Memorandum

Re: 115B Victoria Parade, Fitzroy

On behalf of the City of Yarra I have been instructed to review the urban design merits of the proposal for 115B Victoria Parade, Fitzroy. My comments are based on plans dated 10 November 2017 by Lyons Architects for Australian Catholic University Mother Teresa Building, St. Patricks Campus.

Figure 2.1

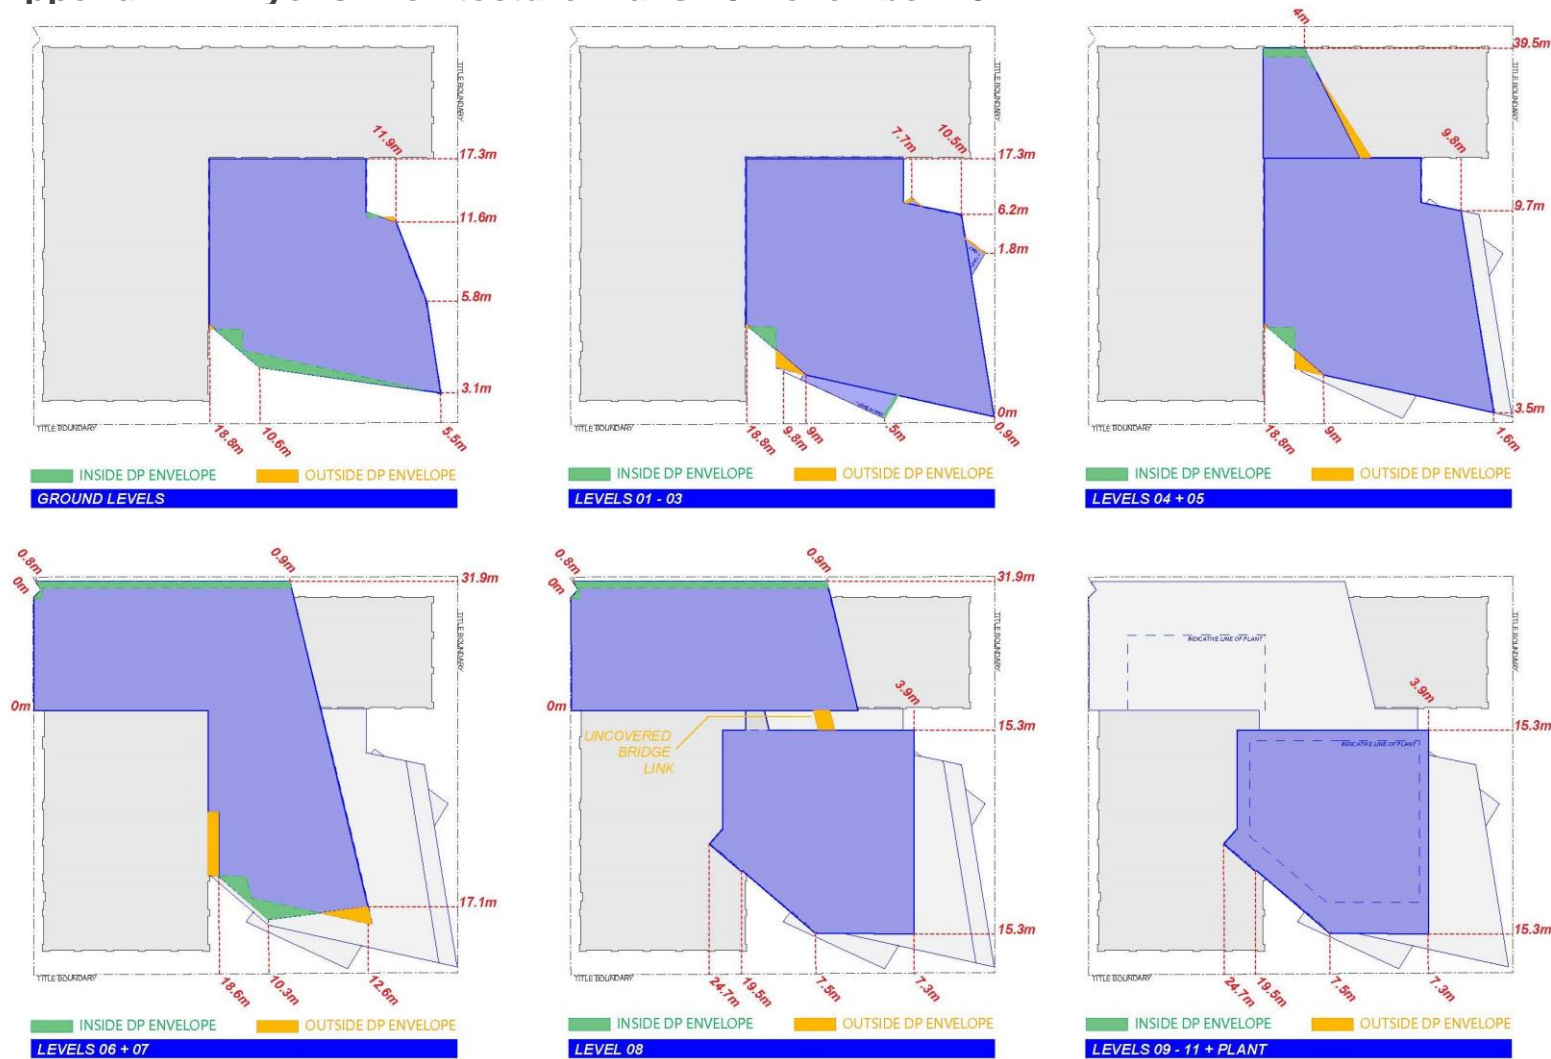
ACU Development Plan St Patricks Campus December 2017 Objective	Requirements of Development Plan	Comments on Lyons Plans (10 November 2017)
Indicative setbacks and floor layout	Refer to page 35 Diagrams of Development Plan	Majority of building envelope complies – some minor protrusions evident in Figure 2.1 .
Indicative section layout and height	Refer to page 56 Diagrams of Development Plan	Complies.
Proposed vehicle and bicycle parking	Maximum 270 car parking spaces, 1 accessible car parking space per 100 cars, 160 bike spaces within entire DPO	244 Car parking spaces 3 Accessible car parking spaces 99 Bicycle spaces For comment by traffic engineer.
Materiality	Glazing, enamelled steel, terracotta glazing, polished aluminium, fritted glass, yellow and dark tinted glazing and white mesh laminated glazing	Proposal includes aluminium shingles to screening element of plant, clear, grey and blue glazing, glazed colour entry, panels with patterning, mesh to the sports courts and glass balustrades. Generally compliant – refer to Figure 2.2 and page 46 of Development Plan.

Figure 2.3

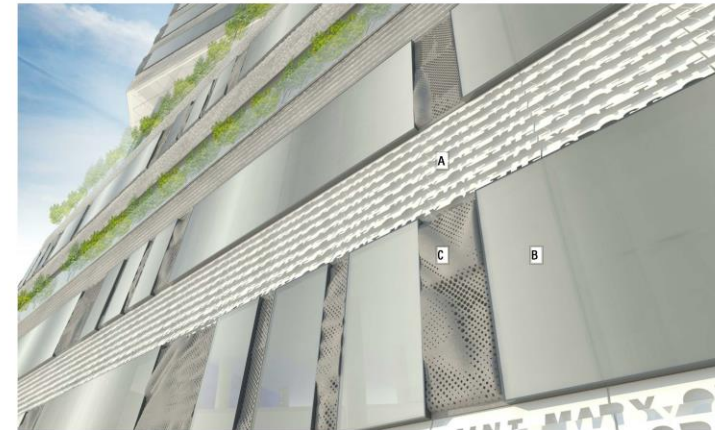
<i>The new building is formally composed such that it allows the two primary ends of the Mary Glowrey Building to be fully expressed in the primary streetscapes. This is achieved by revealing and preserving corners of the Mary Glowrey Building;</i>	Complies (see Figure 2.3).
	<i>The building form of 115B is chamfered to reveal a greater portion of the Mary Glowrey façade as well as softening the impact of the new building on the Victoria Parade streetscape;</i>	Complies – Views down Victoria Parade streetscape show Mary Glowrey Building due to levels 1-5 being cut away (height of building). (Refer to view from Napier and aerial view from Figure 2.2).

<p><i>The ground floor is undercut away from the site boundary on Victoria Parade and Napier Street, revealing valuable urban space at the ground plane as well as providing generous means of circulation around the building from Napier Street and Victoria Parade;</i></p>	<p>Complies (see Figure 2.3 ‘Main Victoria Parade entry and Napier Street Footpath’).</p>
	<p><i>The addition above the Mary Glowrey building is set back from the line of the new 115B building and tapers away from Napier Street to minimise its visual impact on the Mary Glowrey building and on the residential context of Napier Street;</i></p>	<p>The response is consistent with the development plan and the comments of the Tribunal limiting the building to 60m in height.</p>

Figure 2.6

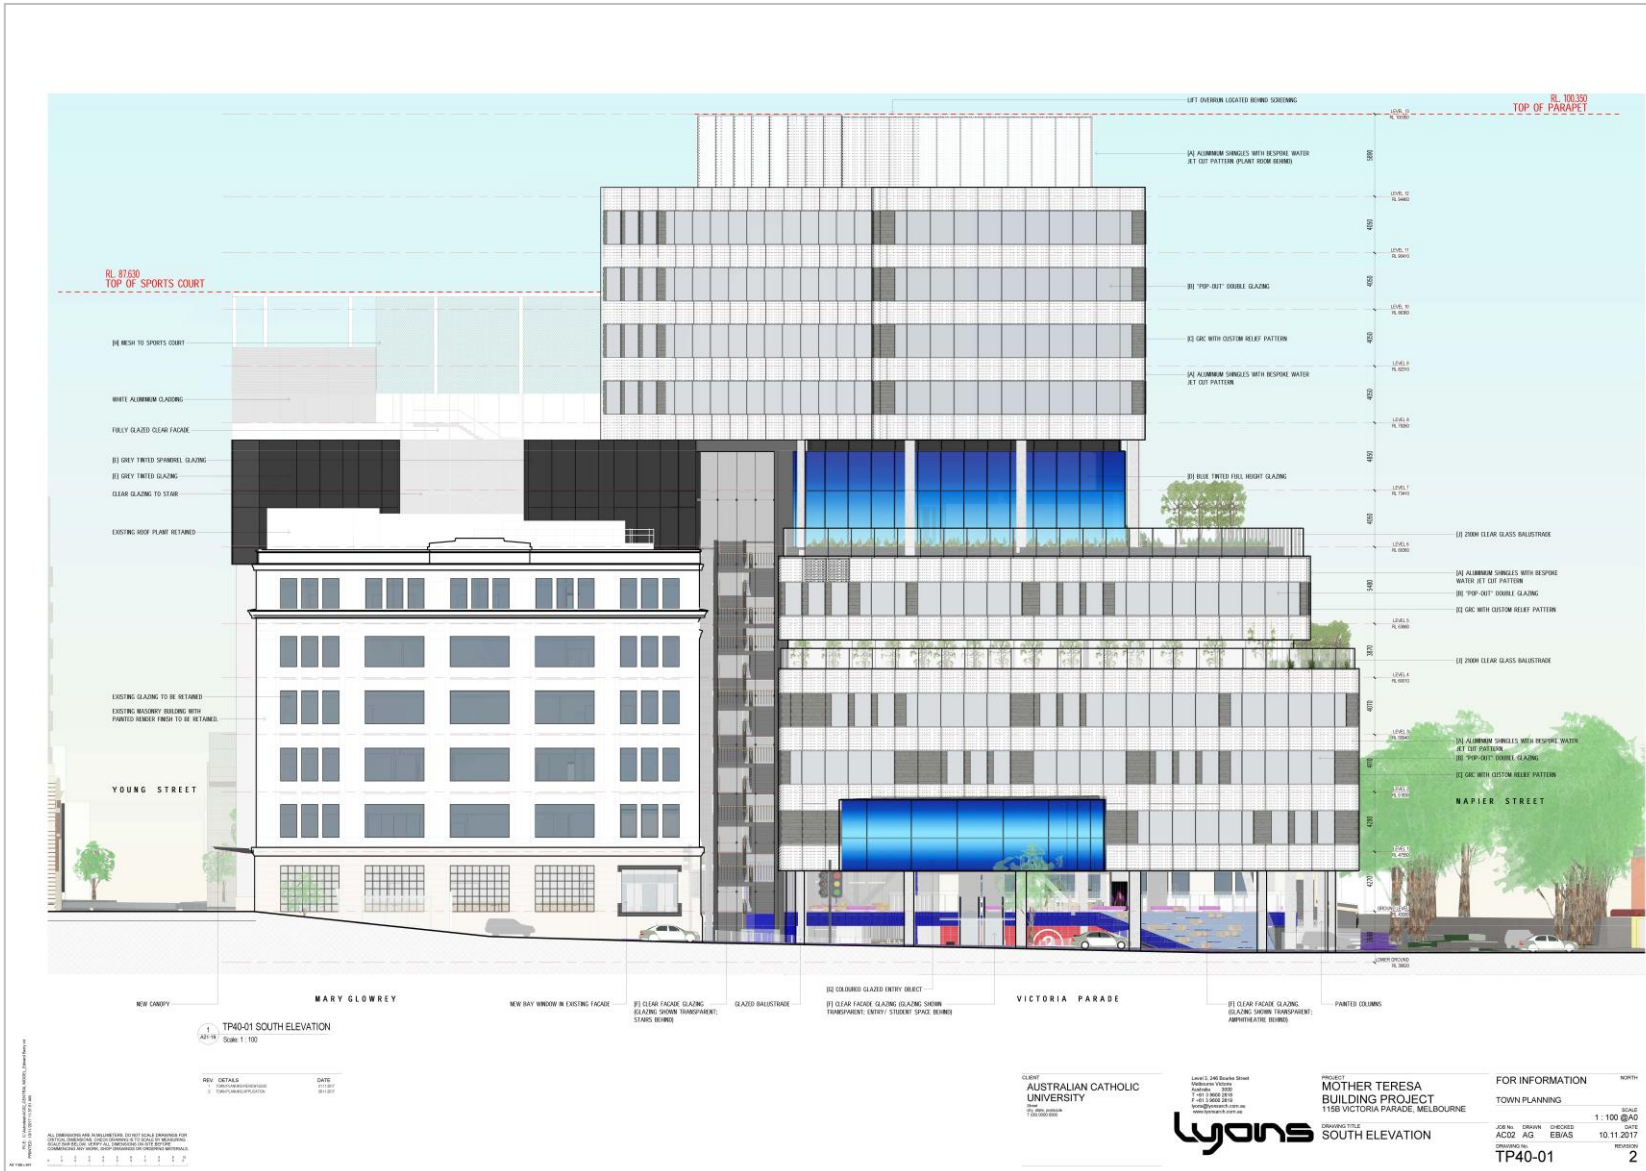
ACU Development Plan St Patricks Campus December 2017 Objective	Requirements of Development Plan	Comments on Lyons Plans (10 November 2017)
Design Guidelines 115B Victoria Parade (Page 51 of Development Plan)	<i>The existing glass façade and ramp arrangement of the Mary Glowrey Building on Victoria Parade is removed to re-establish the heritage façade;</i>	The proposal responds to the requirement as shown in the Ground Floor demolition plan at Figure 2.4 .
	<i>Consolidates a new entry for both the Mary Glowrey Building and the new 115B Victoria Parade building;</i>	Complies, main entry has been relocated onto Victoria Street providing for entry to Mary Glowrey and 115B Victoria Parade (see Figure 2.5).
	<i>The new building consciously steps back from Napier Street, keeping the primary height and mass of the new buildings recessed away from the residential scale of the Napier Street context;</i>	The setback of the south and east elevations appears to satisfy the Development Plan and Tribunal comments in relation to this interface (see South and North elevations at Figure 2.6 and 2.7).
